East Anglia THREE DCO Non-Material Change

Supporting Statement

PROJECT: East Anglia Three Offshore Windfarm

Doc. ID.: EA3-GEN-CON-REP-IBR-000276

Figure 1: 262m Tip Height Turbine Model Indicative Layout – 121 Turbines (Plus 1 Offshore Substation)

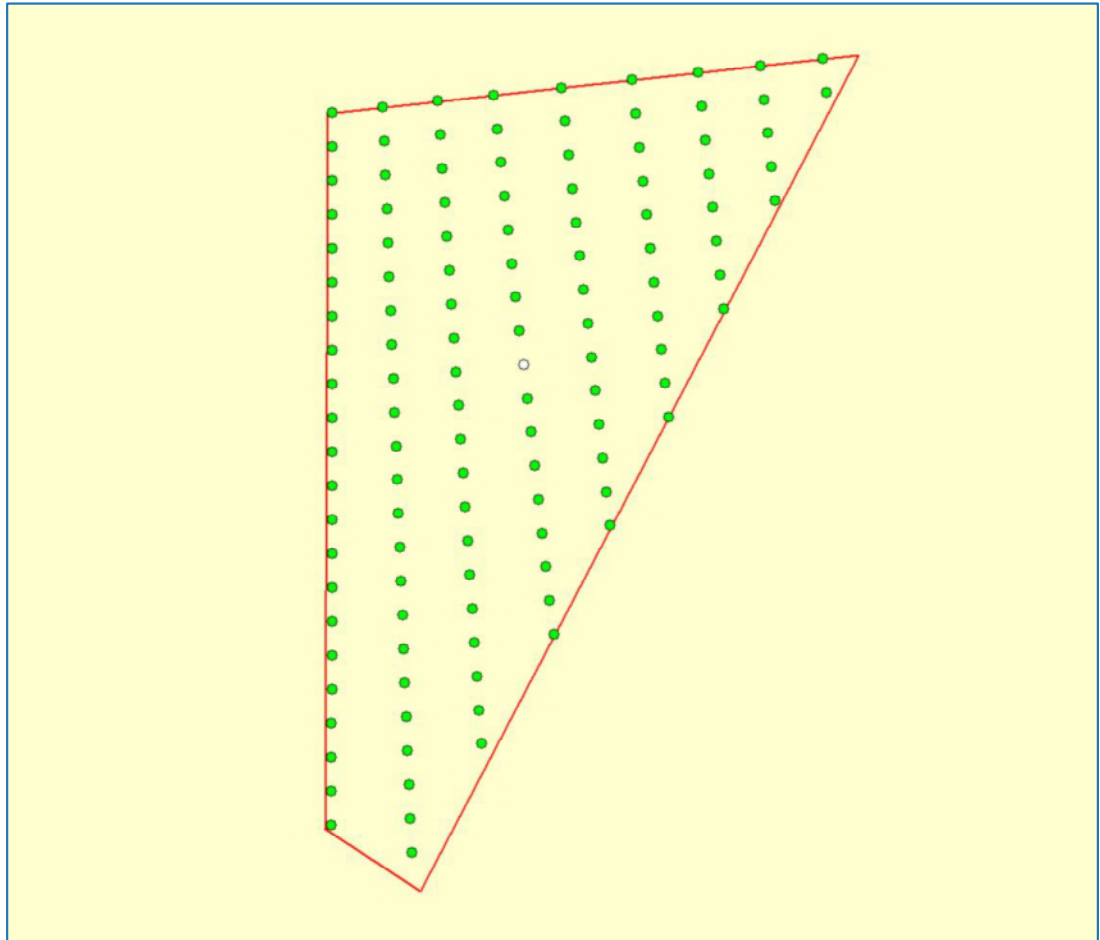
A non-material change (NMC) to the consent for the East Anglia THREE offshore windfarm is proposed which includes an increase of turbine tip height from 247m to 262m and a reduction in the maximum number of turbines from 172 to 121.

1.4.5.5. This turbine layout represents a realistic worst case for radar modelling purposes. Earlier indicative layouts were utilised to inform radar modelling in the Environmental Statement. The key consideration remains radar line of sight. The layout being utilised here provides specific test points across the entire East Anglia THREE footprint where turbines may be deployed in order to assist aviation stakeholders to fully assess the proposed NMC.

Figure 12: Revised Radar Line of Sight Coverage Plan

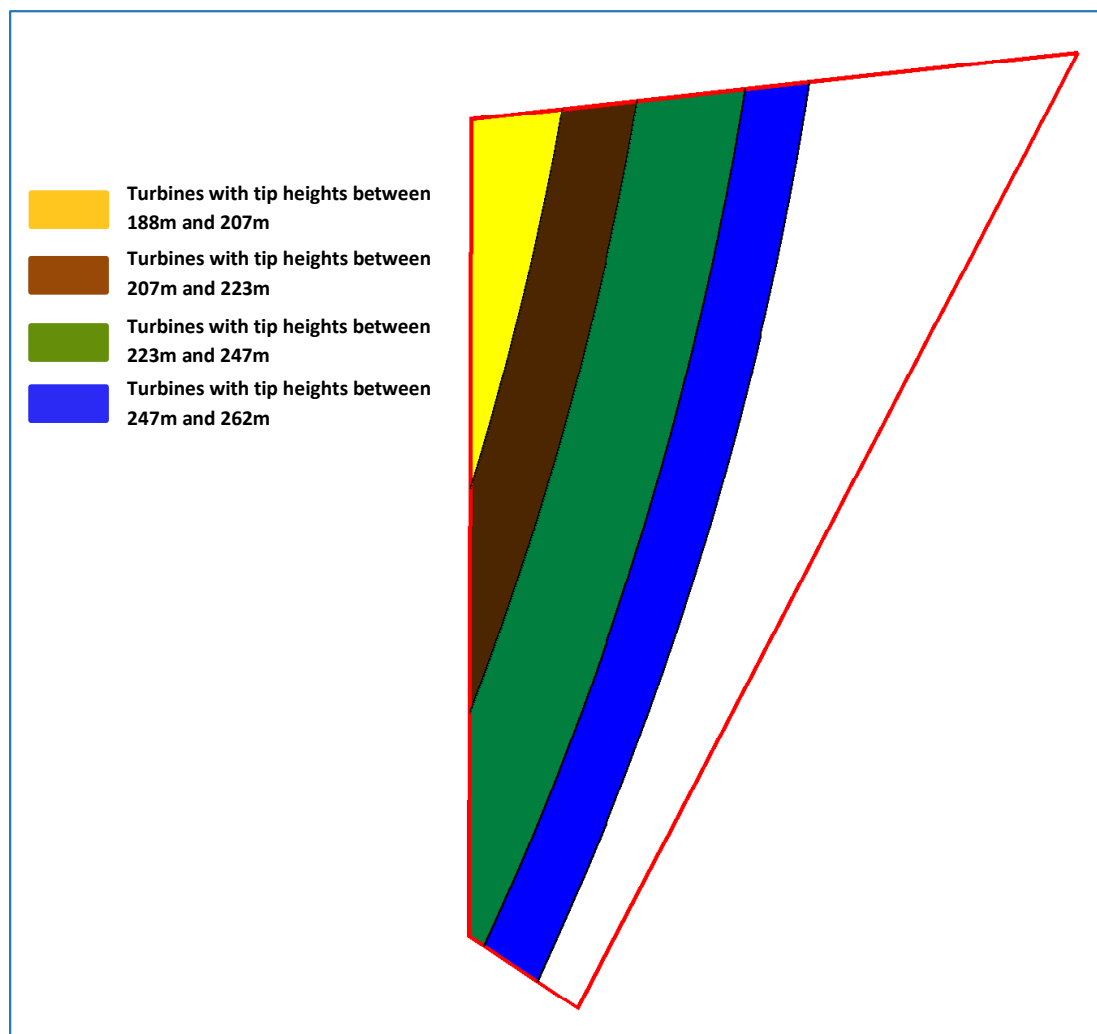
- 1.6.4.2. Calculations in Appendix 16.1 of Volume 3 of the Environmental Statement have already indicated that, in the absence of detailed technical data on the TPS-77 radar, PD and RLoS can effectively be treated as the same for Trimingham radar. This means that wind turbines in the indicative layout with a tip height of 189m or less would be below the RLoS of the Trimingham radar and would require no further mitigation. If the wind turbine tip heights exceed the relevant RLoS heights as shown in Figure 9 in those areas, then it can be assumed that any turbines in RLoS of Trimingham radar will be detected by the radar and a technical mitigation solution will be required for the MOD Trimingham radar. DCO Requirement 33 provides for such mitigation, albeit a minor amendment is required to reflect Figure 12 below. The Radar Line of Sight Coverage Plan (document 2.11, as certified under the DCO) also requires revision so as to reflect Figure 12 below.

- 1.8.1. For MOD Trimingham radar, the modelling concludes that the principle of the mitigation remains appropriate to mitigate significant effects, albeit that a minor amendment of DCO Requirement 33 and an updated Radar Line of Sight Coverage Plan is required to refer to the increase in tip height to 262m and the eastward shift of the 207m, 223m and 247m tip height RLoS contours (to reflect the updated Antenna Aperture height).

Figure 19: Cromer Radar PD of 262m Turbines with Reduced Antenna Gain

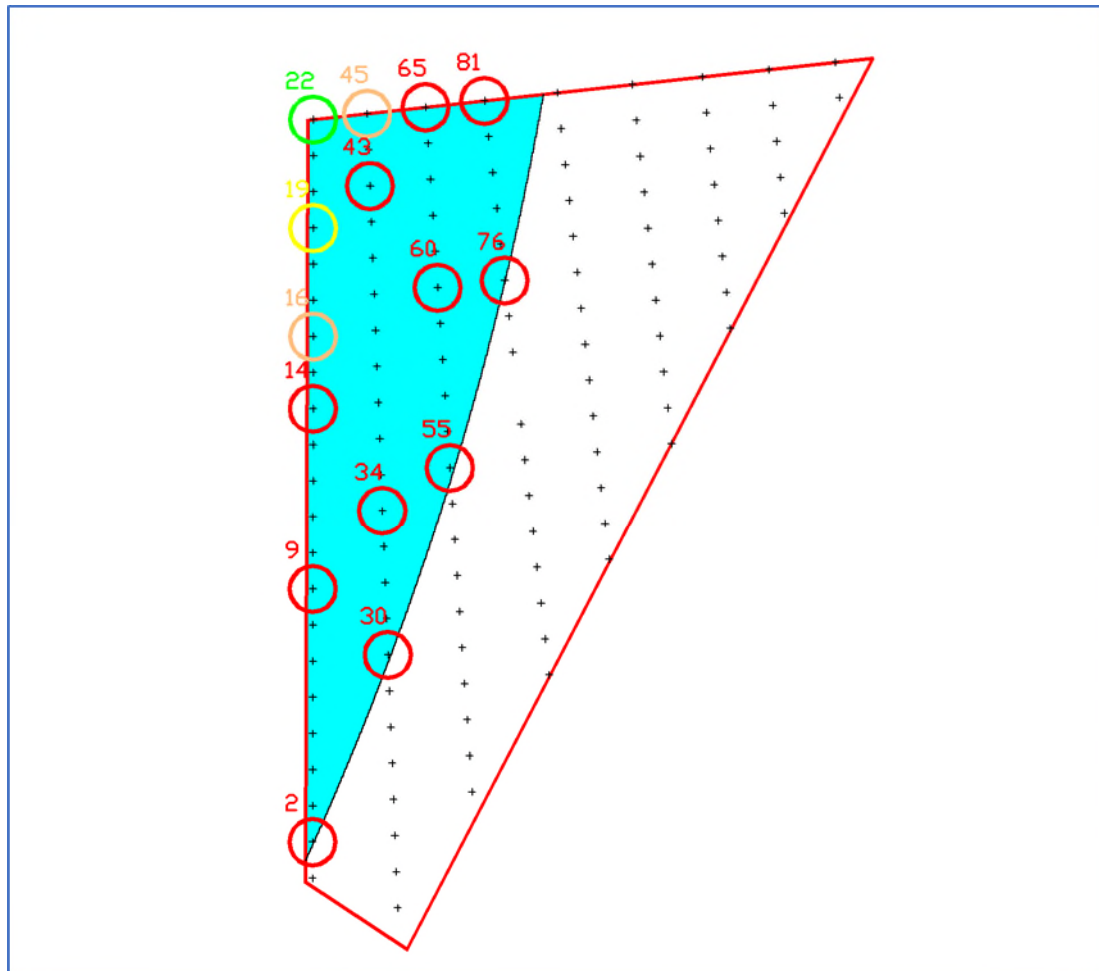
- 1.7.4.21. The colour-coded results are illustrated in Figure 19 and suggest that all but the closest 10 of the 121 turbines in the 262m indicative layout are unlikely to be detected by Cromer radar. This represents an impact not experienced in the original ES, where, as noted in paragraph 1.7.4.4 above, NATS concurred with the ES conclusion that no turbines at 247m would be detected by Cromer PSR.

- 1.7.4.22. Although up to 10 turbines of the indicative layout are detected by Cromer PSR, this small detection increase is not considered to represent a change to the ES conclusion that there would be no significant impact on NATS Cromer radar. Notwithstanding this, and if considered necessary, measures are available to mitigate the detection of Wind Turbine Generators (WTGs) by the NATS Cromer radar in the form of blanking alone or together with a Transponder Mandatory Zone (TMZ), which measures can be secured through a DCO Requirement if required.
